Subject: **Modification Request for Section 404 Nationwide Permit (NWP) 23 and Section 401 Water Quality Certification** for the widening of Kerr Avenue (SR 1175) from Randall Parkway to Martin Luther King, Jr. Parkway (SR 2649); TIP Project U-3338B; Federal Aid Project No. STP-1175(8), Debit \$570 from WBS No. 34932.1.1.

References: Section 404 NW 23 Action ID SAW-2003-01069 issued May 22, 2014  
Section 401 WQC Project No. 14-0350 issued May 12, 2014

Permit Drawing  
 Sheet 14 of 20  
 Revised 5/11/2017

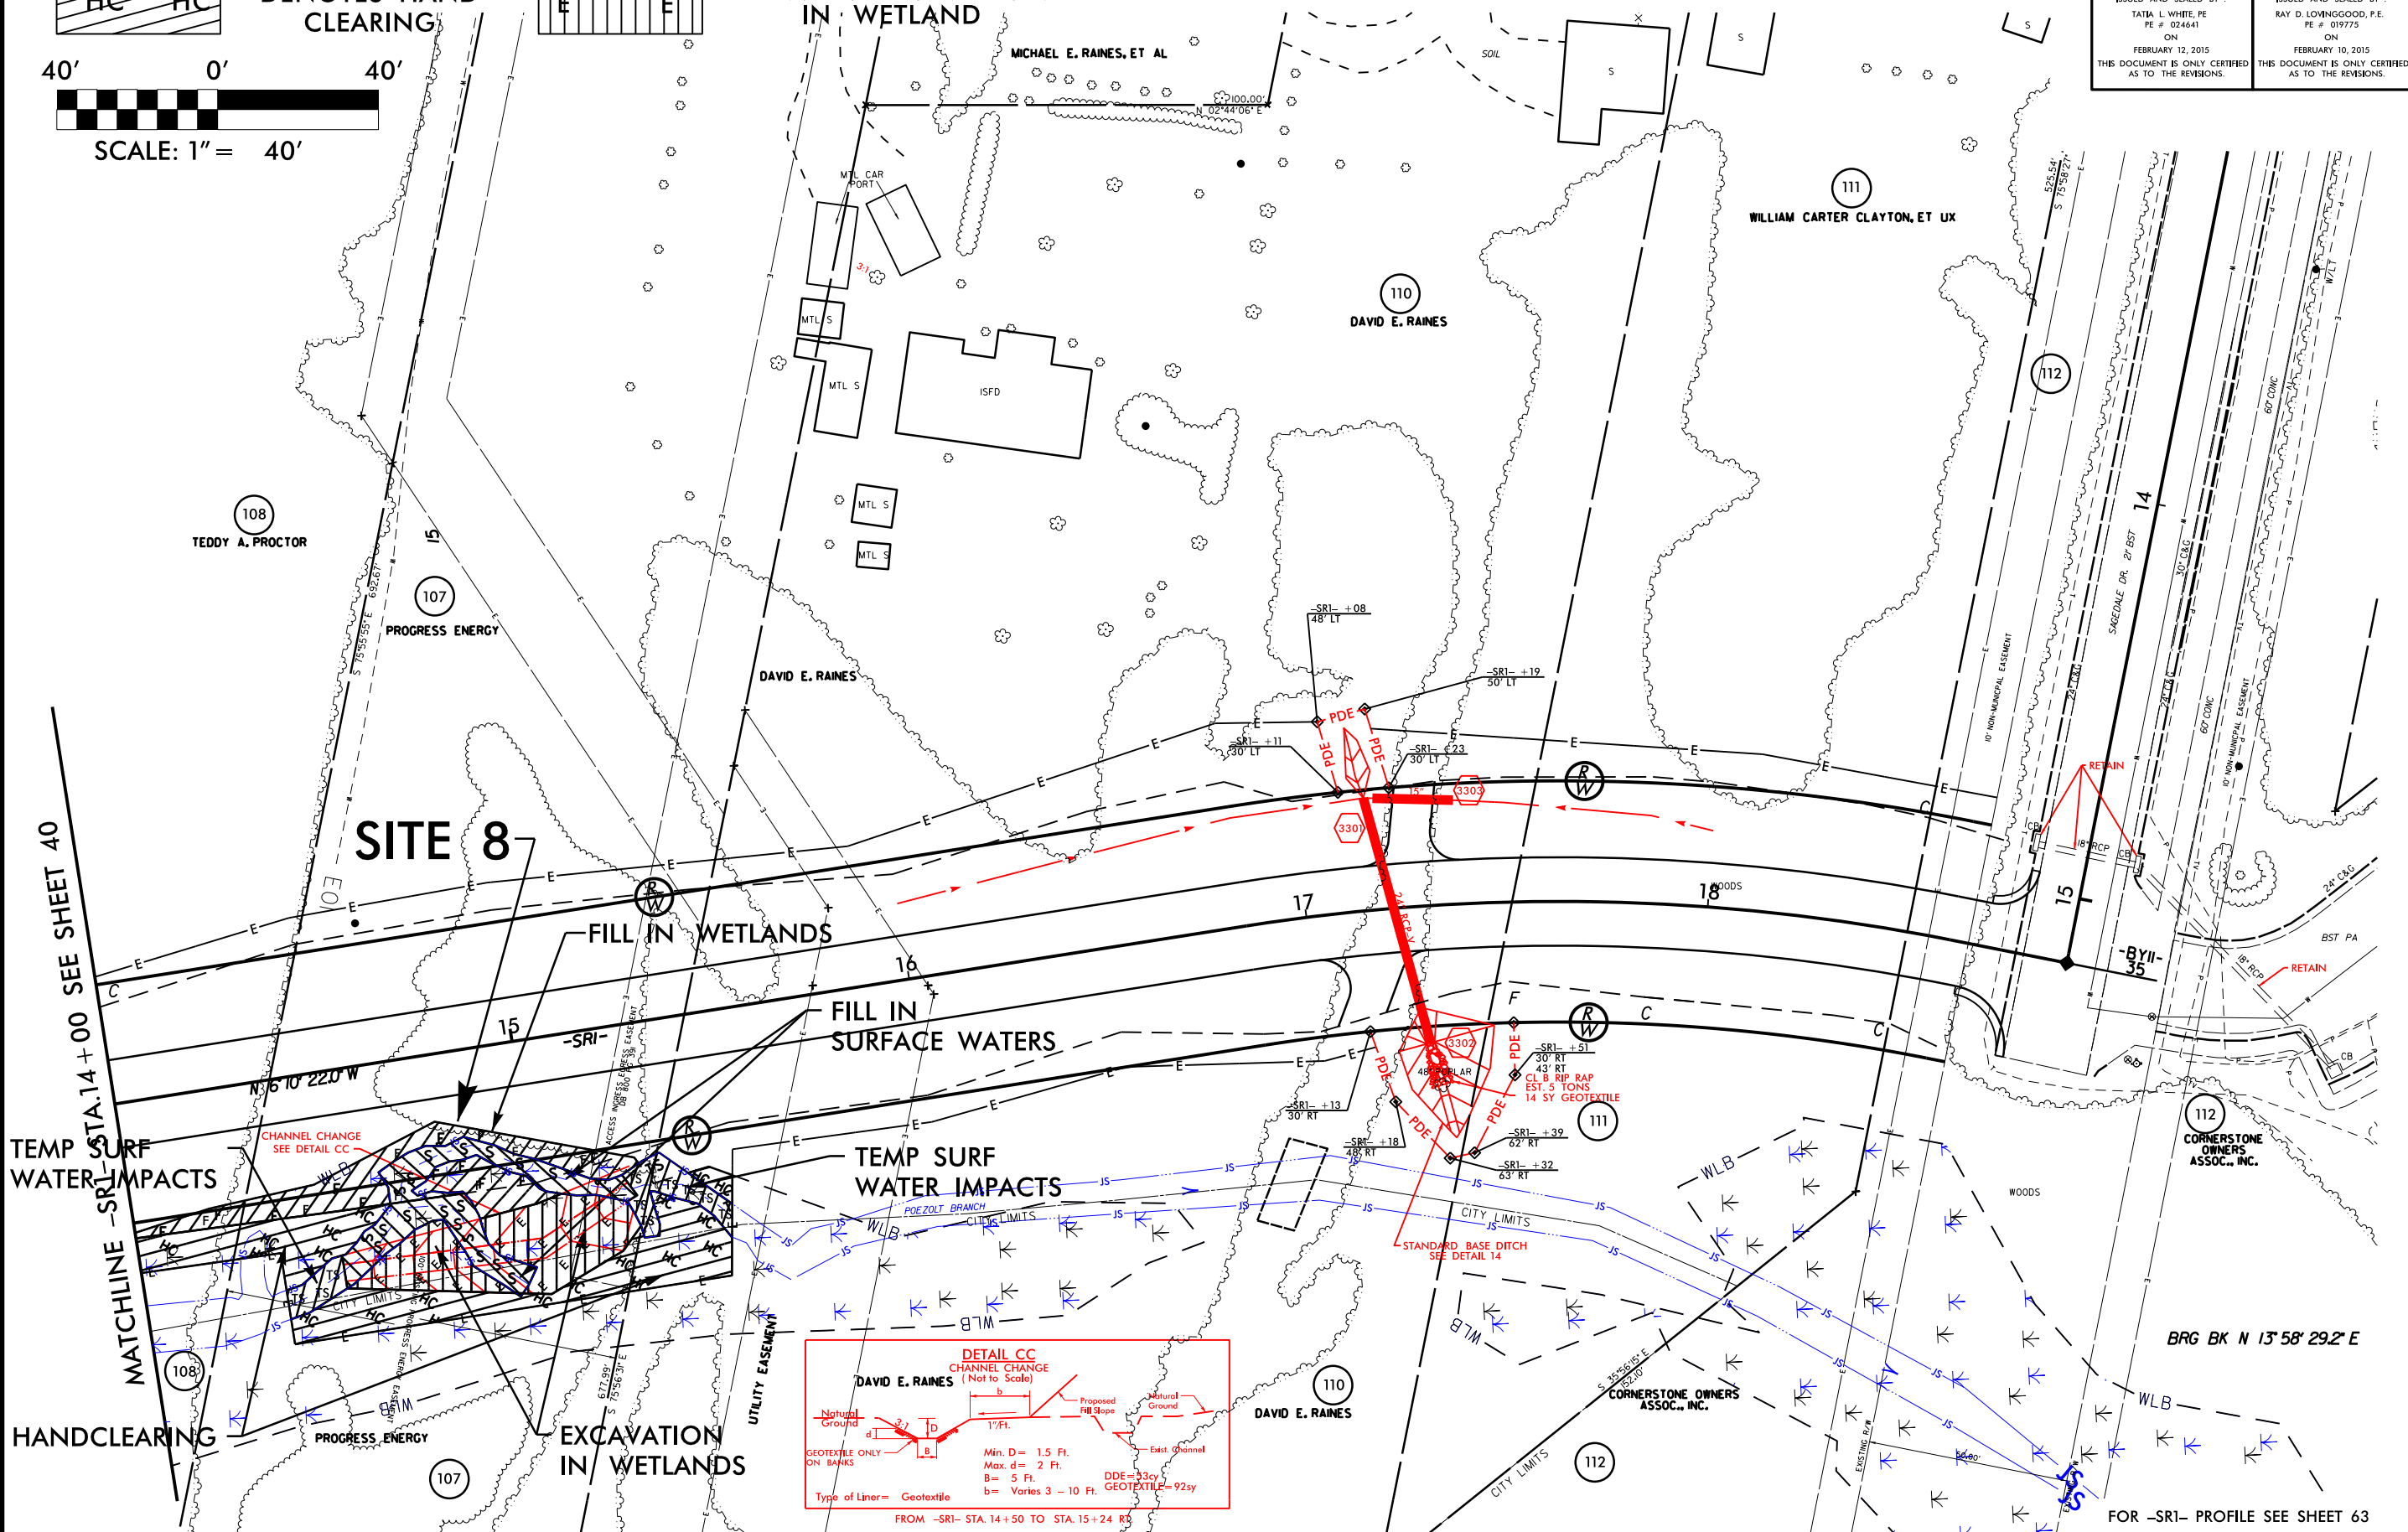
4/11/2017 rlovinggood  
 K:\Hydraulics\PERMITS\_Environmental Drawings\Construction\Revision April 2017\U-3338B\_Hyd\_prm\_wet\_psh\_41 - Rev 1  
 0406417 - CONST.RW REVISIONS: REVISED THE LOCATION OF JS STREAM AND INCLUDED DETAIL CC FOR A CHANNEL CHANGE AND REVISING THE TCE ON PARCELS 107 AND 110. - TLW

Permit Drawing  
 Sheet 15 of 20  
 Revised 5/11/2017

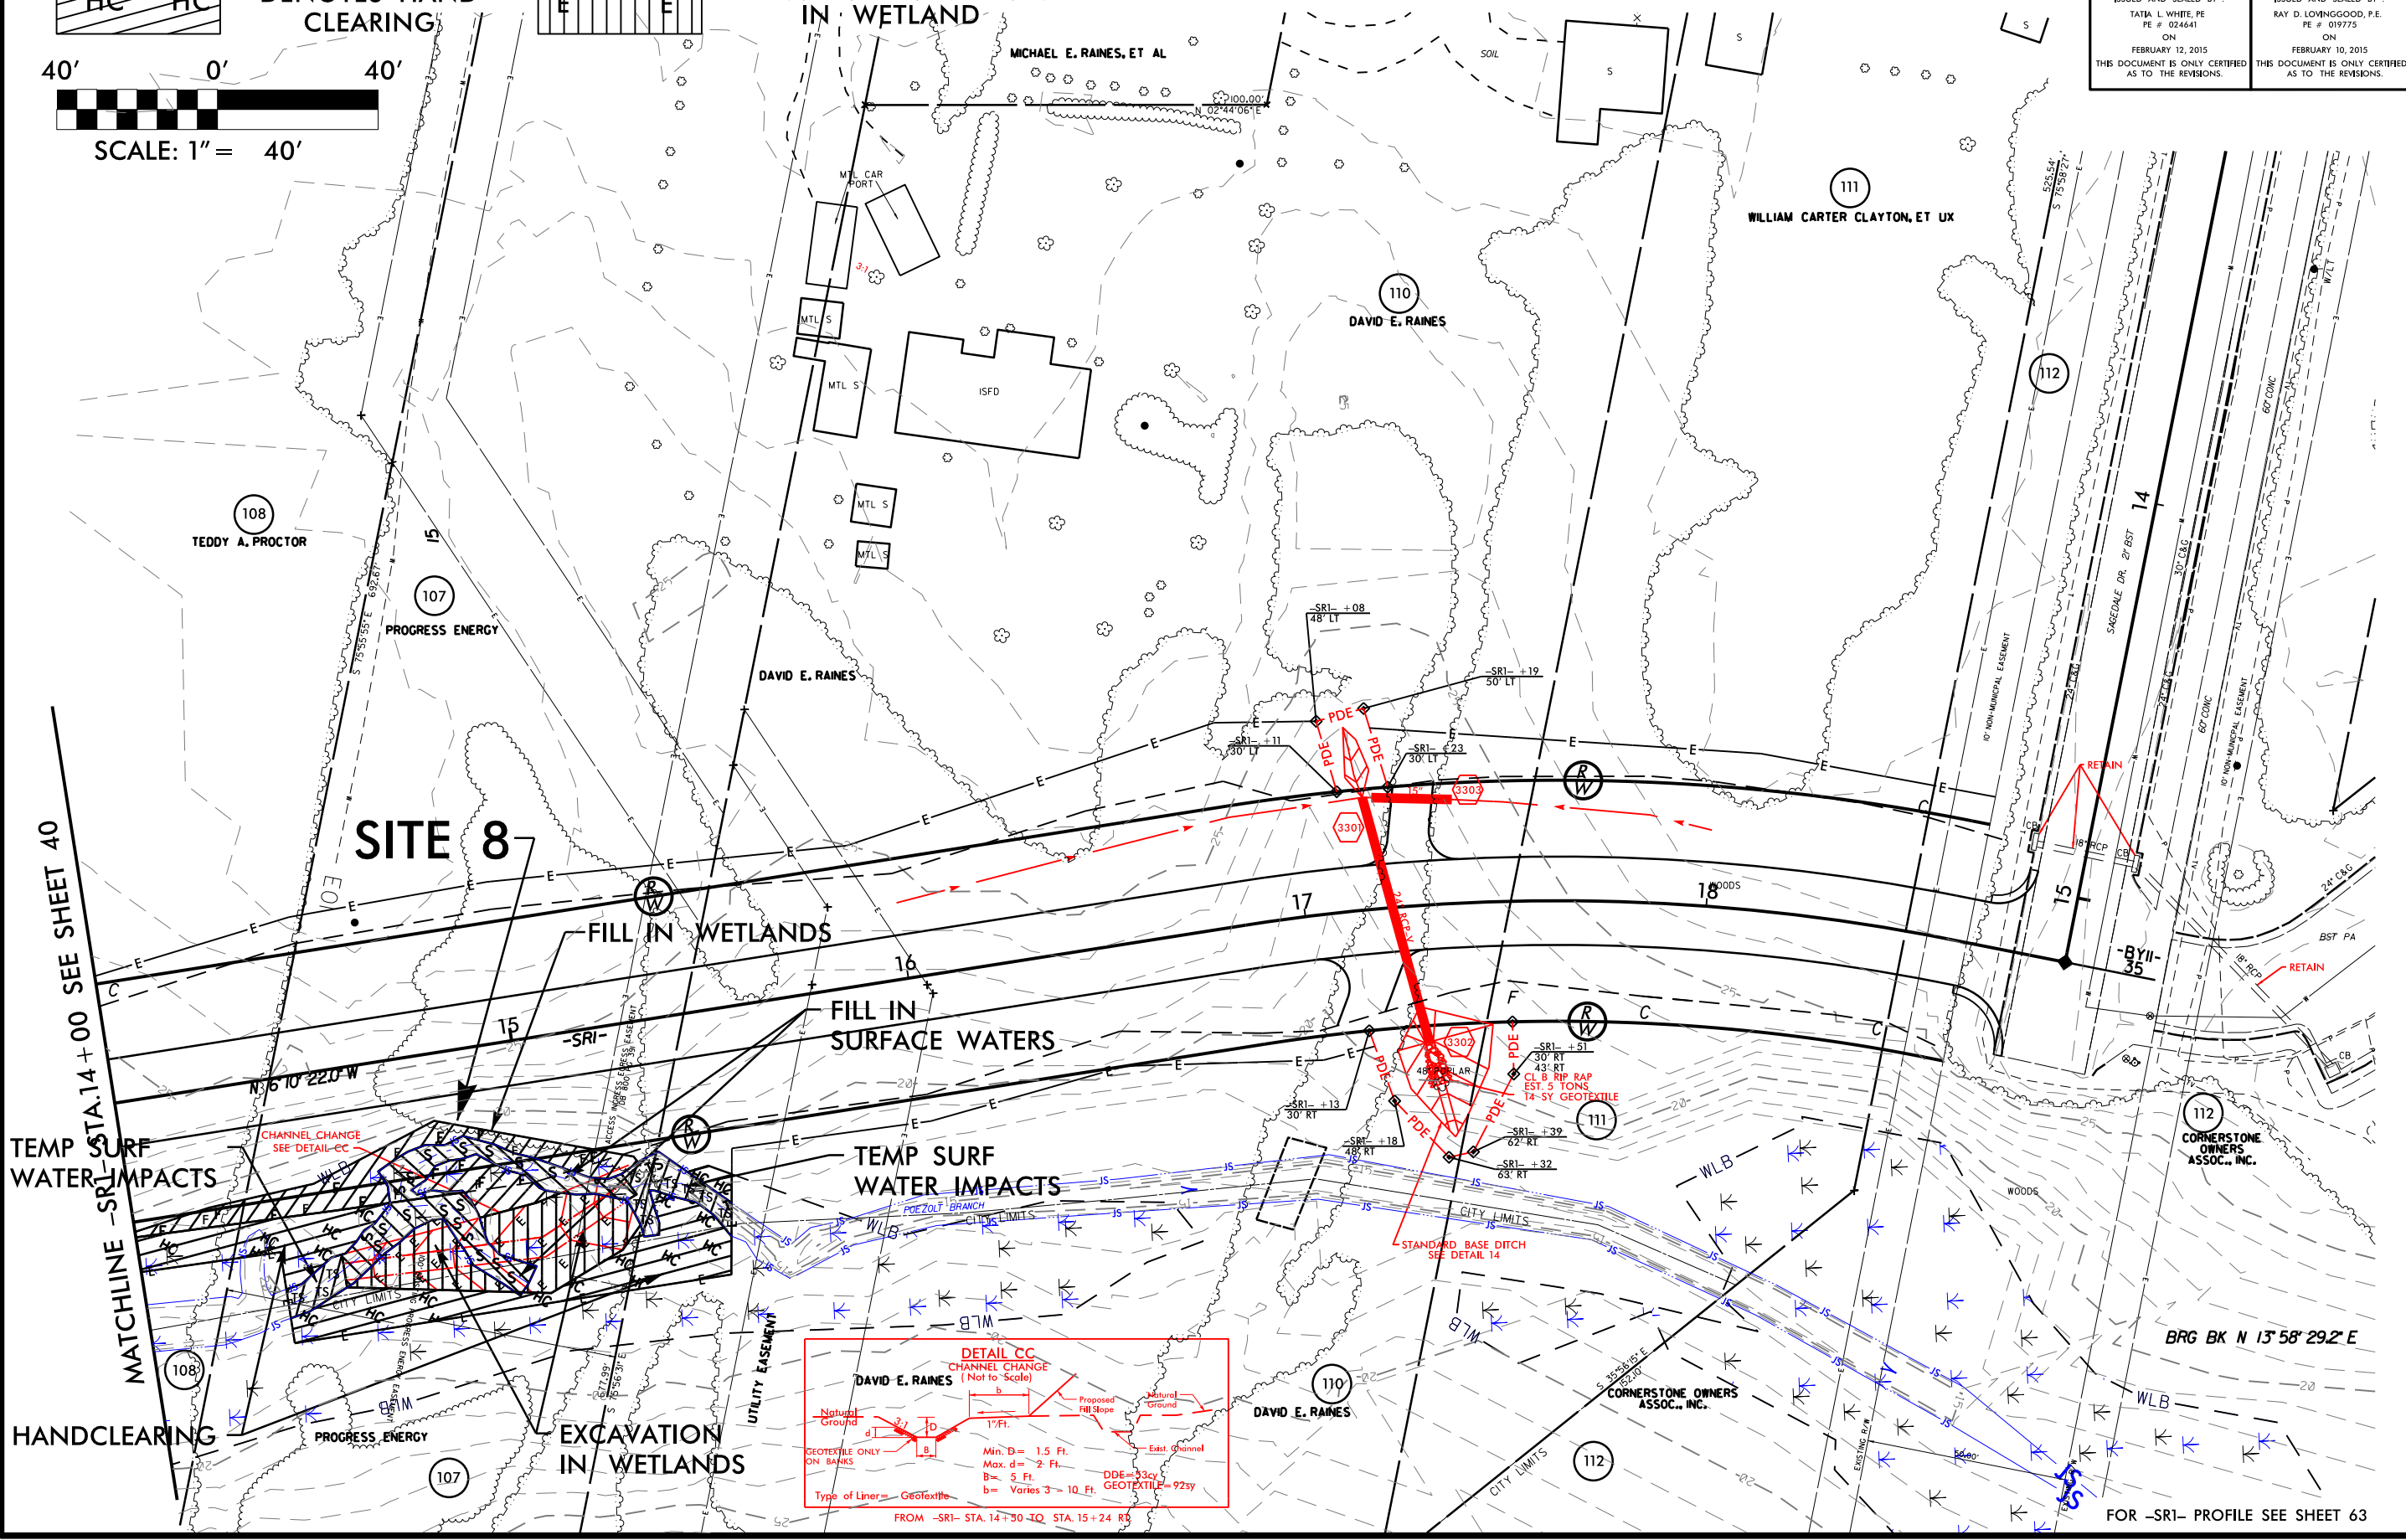
4/11/2017 rlovinggood  
 K:\Hydraulics\PERMITS\_Environmental Drawings\Construction\Revision April 2017\U-3338B\_Hyd\_prm\_wet\_psh\_41 - Rev 1  
 040617 - CONST.RW REVISIONS: REVISED THE LOCATION OF JS STREAM AND INCLUDED DETAIL CC FOR A CHANNEL CHANGE AND REVISING THE TCE ON PARCELS 107 AND 110. - TLW

Added 5/11/17

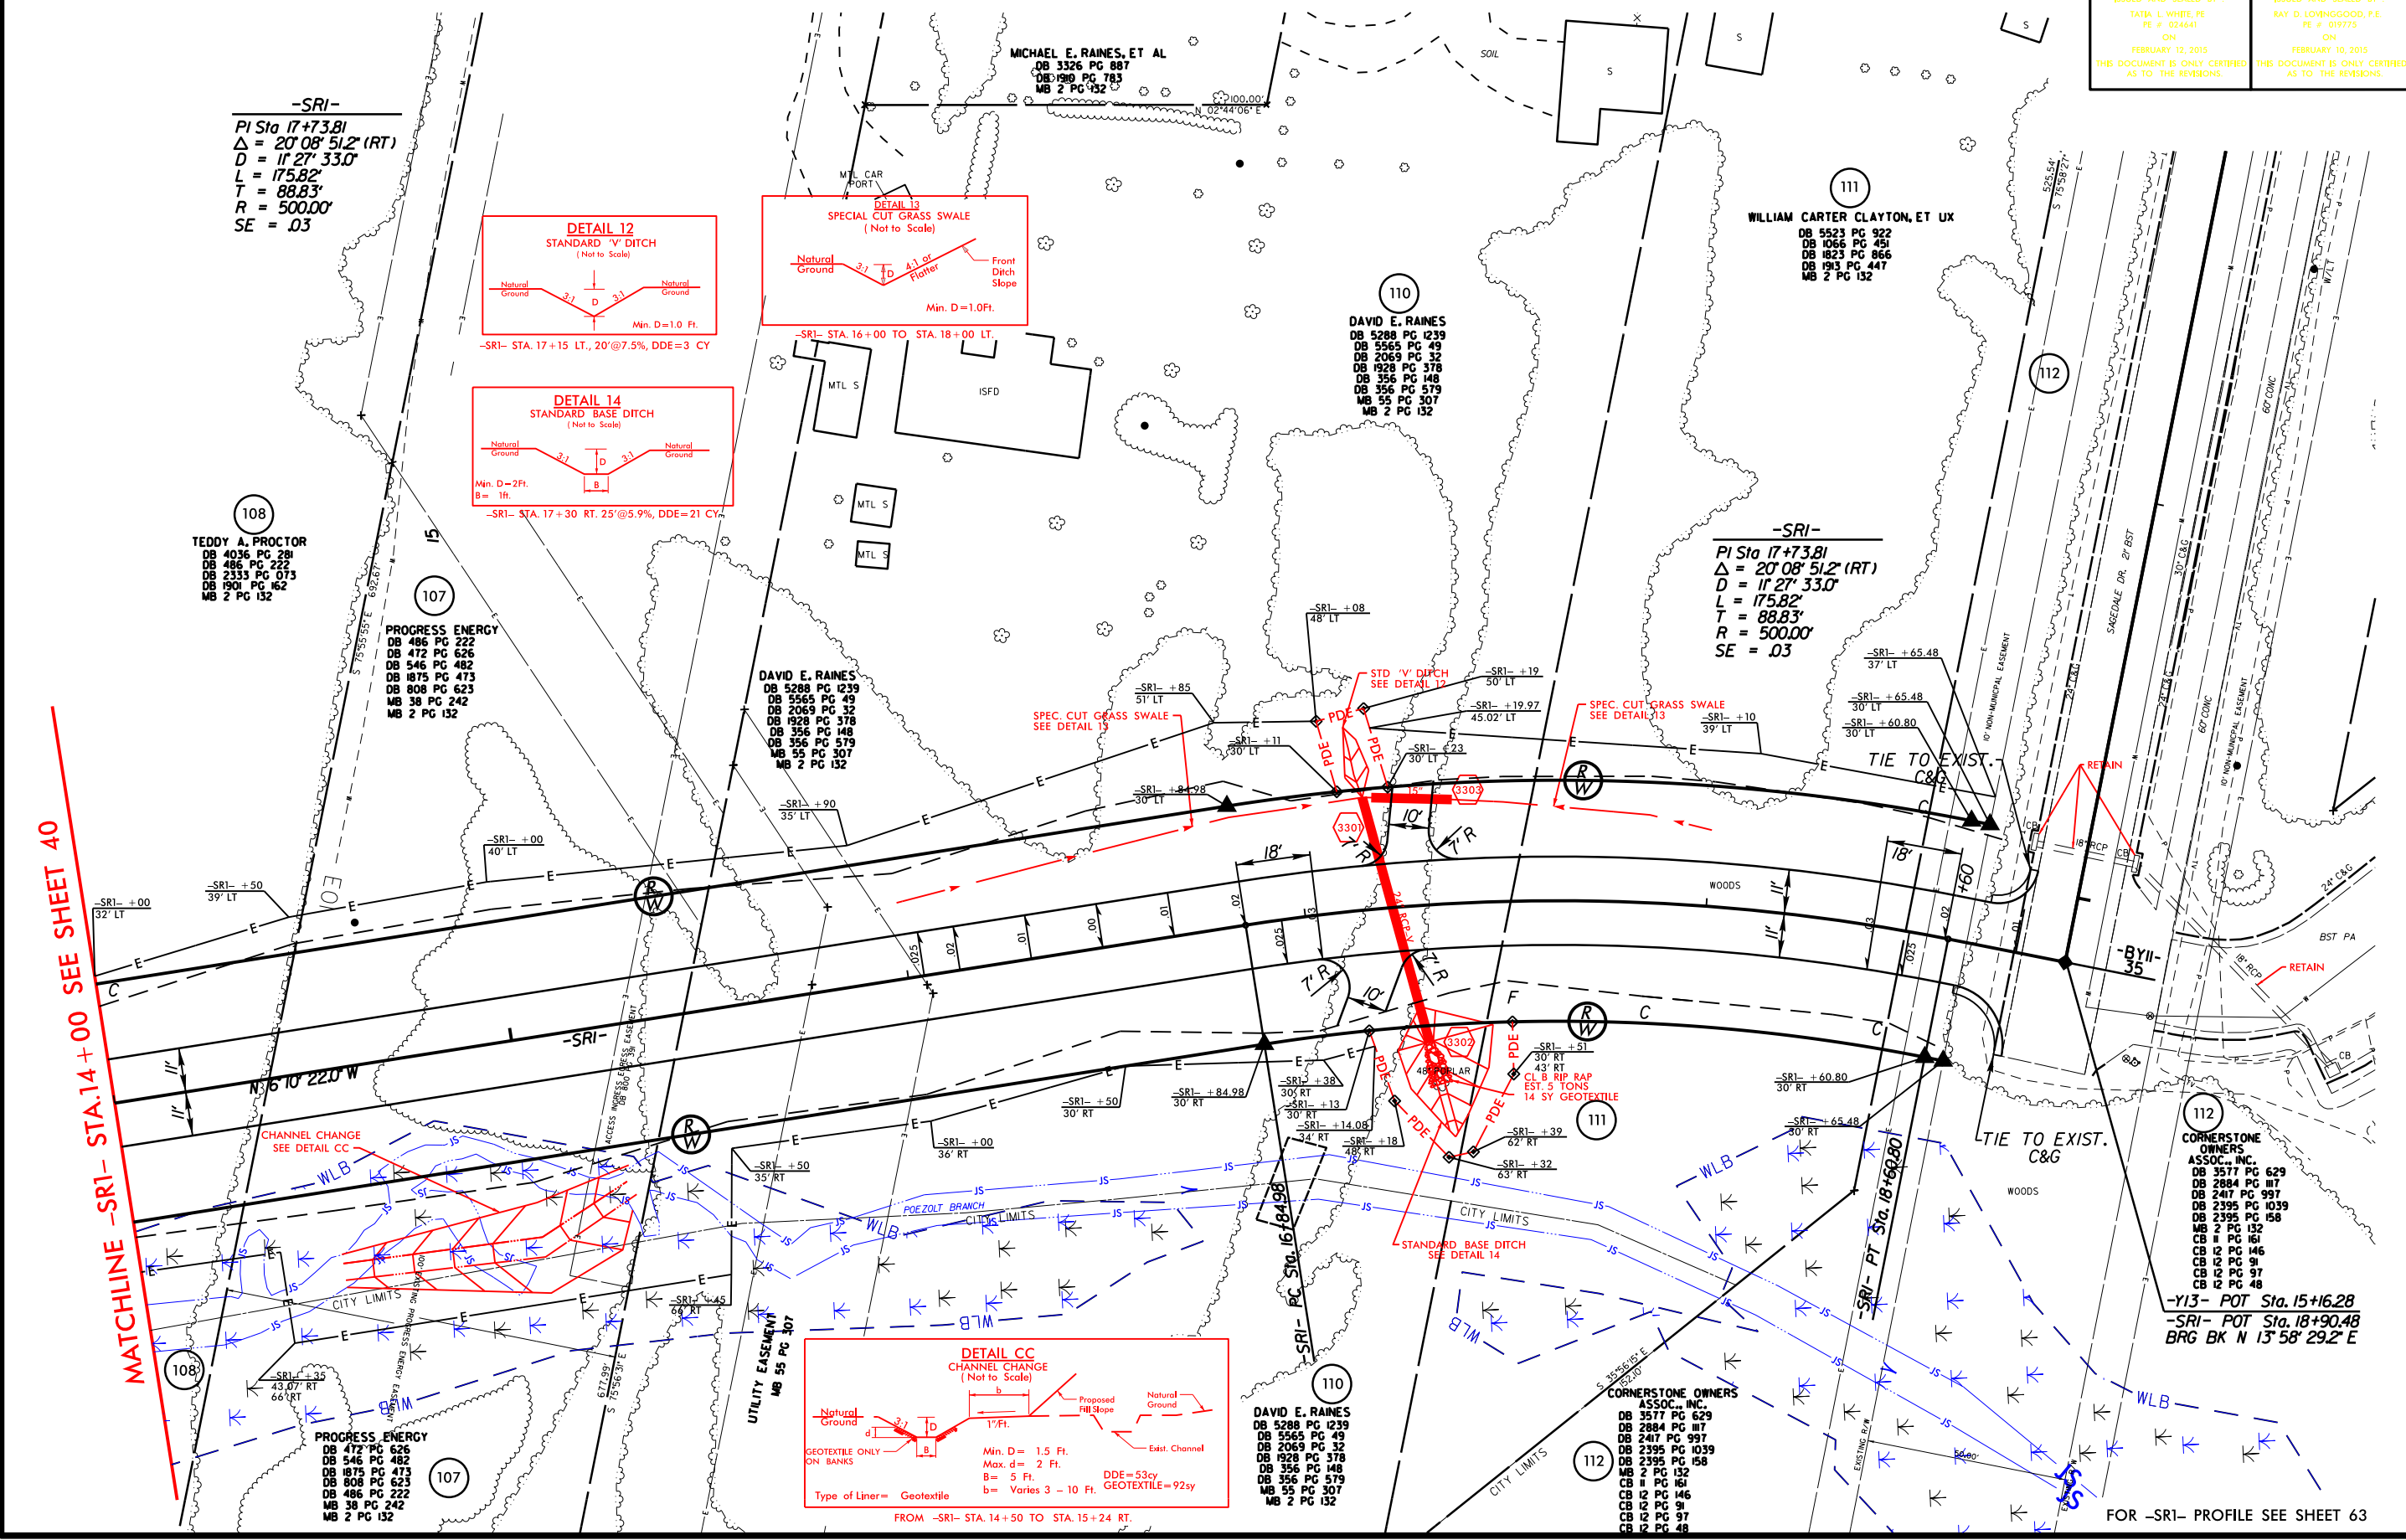
04/06/17 - CONST. RW REVISIONS: REVISED THE LOCATION OF JS STREAM AND INCLUDED DETAIL CC FOR A CHANNEL CHANGE AND REVISING THE TCE ON PARCELS 107 AND 110. - TLW
